SUBJECT: SPIRIT LAKE/TROJAN PLANT FLOODING SER

HYDROLOGIC ENGINEERING SAFETY EVALUATION REPORT
CONCERNING A POSTULATED BREAKOUT OF SPIRIT LAKE
AND ITS IMPACTS ON THE TROJAN PLANT

FIGURE 2
LOCATION OF SPIRIT LAKE OUTLET

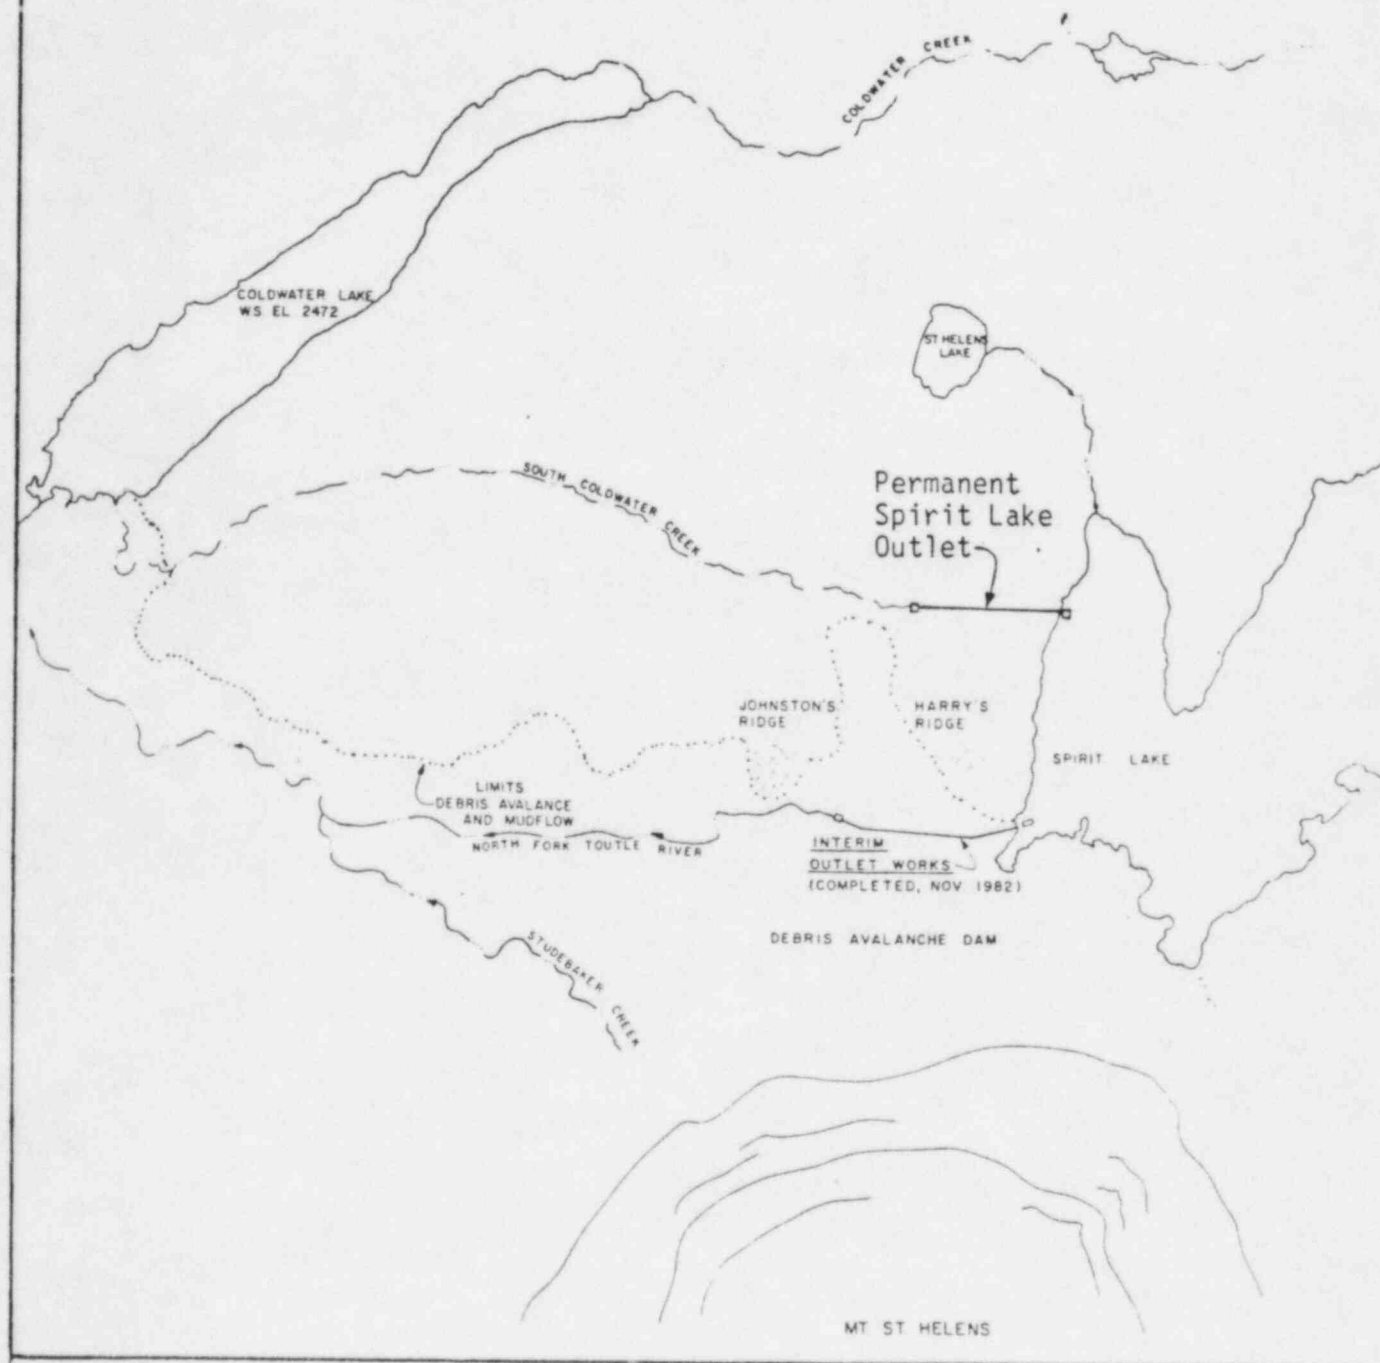
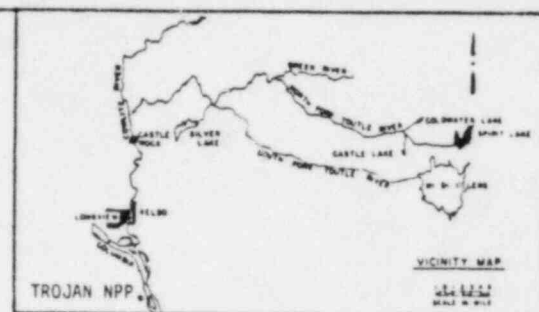
The tunnel being constructed between Spirit Lake and South Coldwater Creek (See Figure 2) will provide a permanent outlet for Spirit Lake. This tunnel will permanently lower the level of Spirit Lake and remove the threat of a breakout and the potential for high water in the Columbia River at the Trojan Plant.
